LaSalle County Station, Units 1 and 2
Renewed Facility Operating License Nos. NPF-11 and NPF-18
NRC Docket Nos. 50-373 and 50-374

Subject: Supplemental Information Regarding License Amendment Request – Relocation of Pressure and Temperature Limit Curves to the Pressure and Temperature Limits Report

Summary of Corrections to PTLR

Pressure and Temperature Limits Report (PTLR)

Figure 2: LSCS Unit 1 P-T Curve B (Normal Operation – Core Not Critical) for 54 EFPY

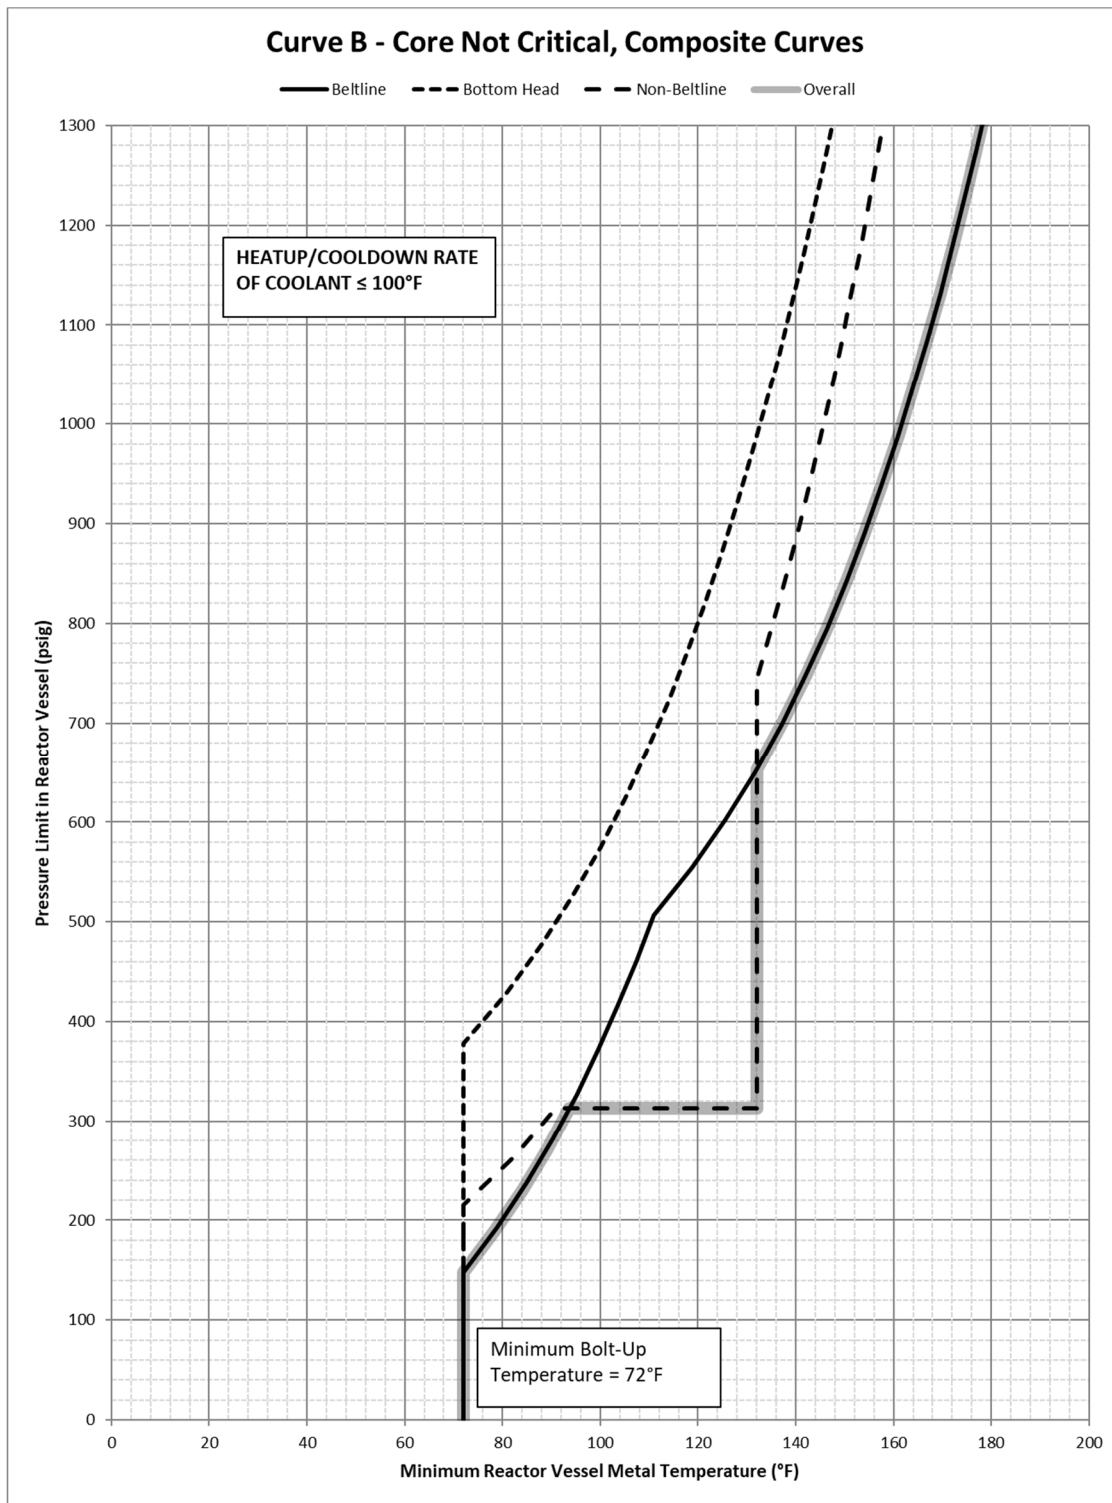
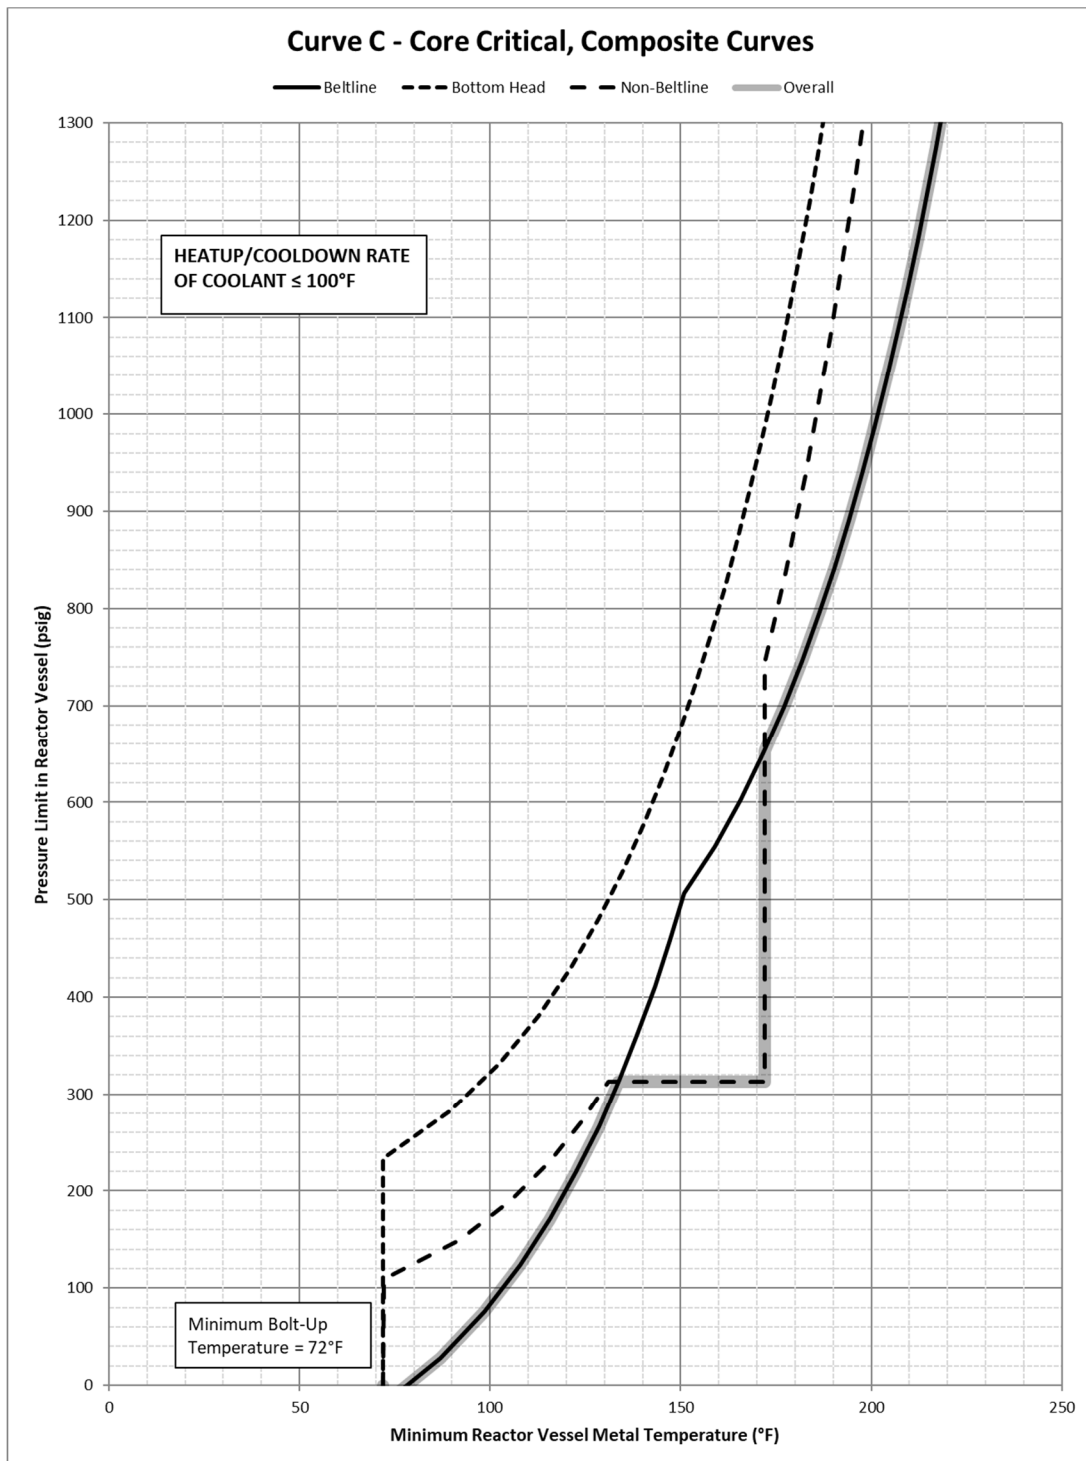
Input change of the atmospheric pressure adjustment to 14.7 psi. The Scale K_{IT} based on Saturation Temperature was Yes for Feedwater Nozzle in the calculation but the report said NO in the input. This affected the results of Unit 1 Curve B and C and Unit 2 Curve C.

Page 1	Revision Number Change
Page 6	Administrative – Clarified that the heat-up/cool-down rate of the coolant (Curve B) is $\leq 100^{\circ}\text{F}/\text{hour}$ (previous confusion with SRV Blowdown Event of $\leq 155^{\circ}\text{F}/\text{hour}$). Subnote 2 was added to end of page.
Page 7	Formatting due to the changes on Page 6
Page 9	Administrative - Added "Single Relief or Safety Valve" next to "(SRV)"
Page 14	Reference 6, updated revision
Page 15	Administrative – Updated dated References 17, 18, and 28 to "Month Year" rather than "Month Day, Year"
Page 16	Administrative – Added Heat-Up/Cool-down rate to figure
Page 17	Non-Beltline Curve updated (Values Located in Table 2 for Non-Beltline). Additionally, the Heat-Up/Cool-down rate was added to the figure (administrative).
Page 18	Non-Beltline Curve updated (Values Located in Table 3 for Non-Beltline). Additionally, the Heat-Up/Cool-down rate was added to the figure (administrative).

Figure 3: LSCS Unit 1 P-T Curve C (Normal Operation – Core Critical) for 54 EFPY

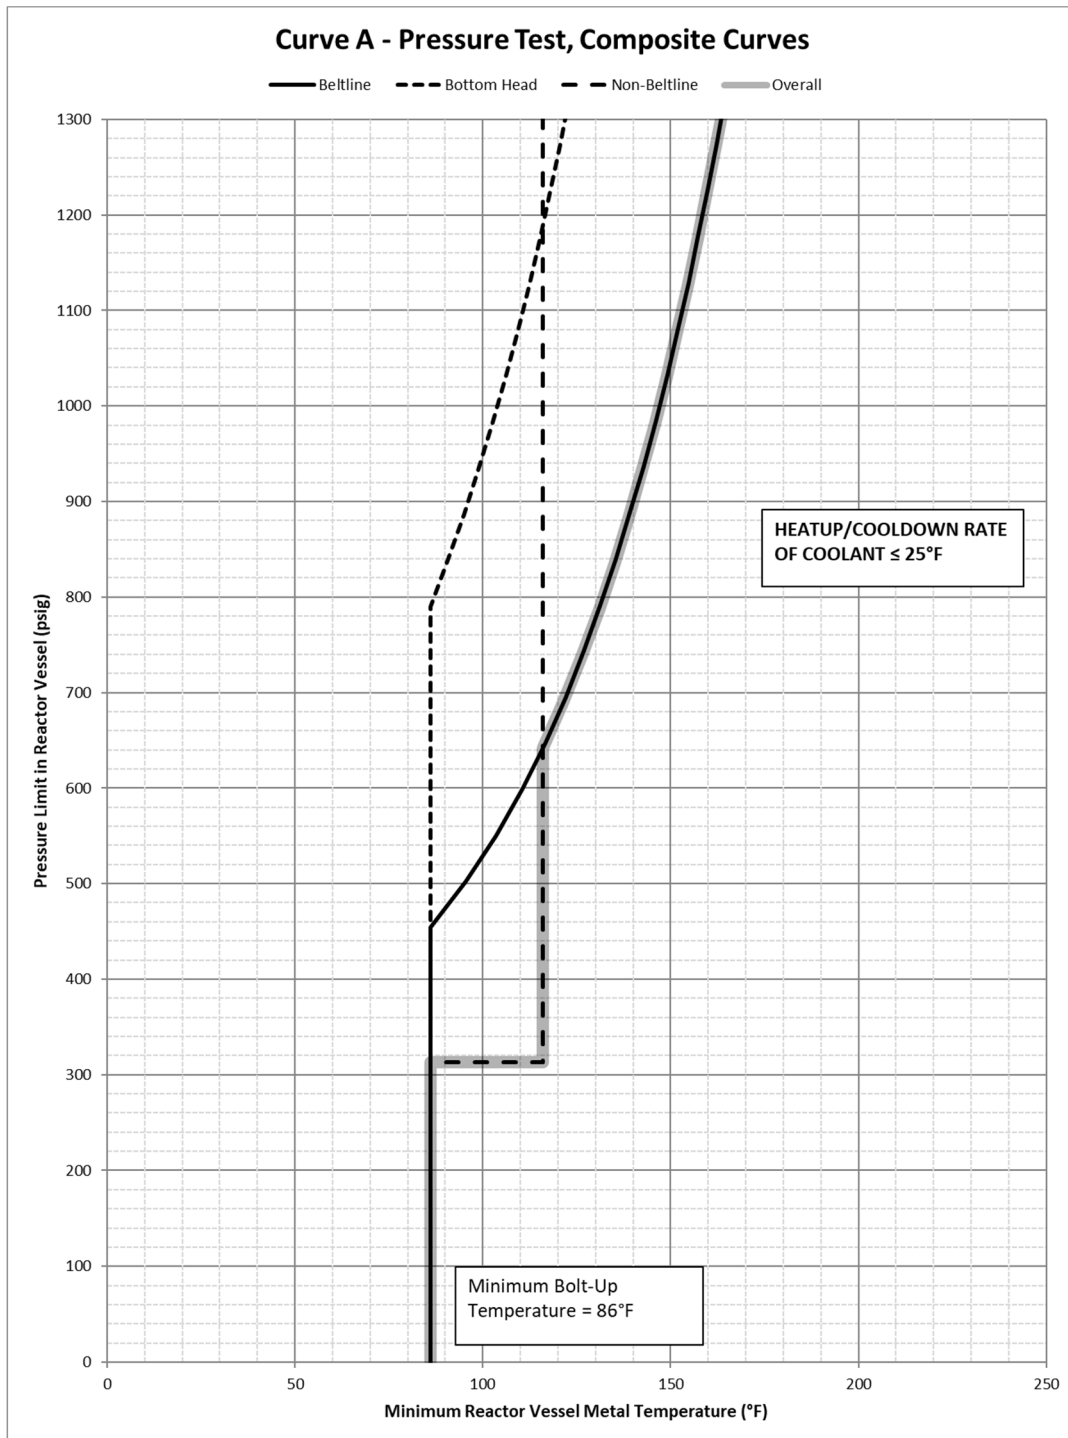
Page 19	Administrative – Added Heat-Up/Cool-down rate to figure
Page 20	Administrative – Added Heat-Up/Cool-down rate to figure
Page 21	Beltline and Non-Beltline Curve updated (Values Located in Table 6 for Beltline and Non-Beltline). Additionally, the Heat-Up/Cool-down rate was added to the figure (administrative).
Page 31	Values were updated in Table 2 Unit 1 Curve B for Non-Beltline Region.
Page 35	Values were updated in Table 3 Unit 1 Curve C for Non-Beltline Region.
Page 42	Values were updated in Table 6 Unit 2 Curve C for Beltline Region.
Page 44	Values were updated in Table 6 Unit 2 Curve C for Non-Beltline Region.
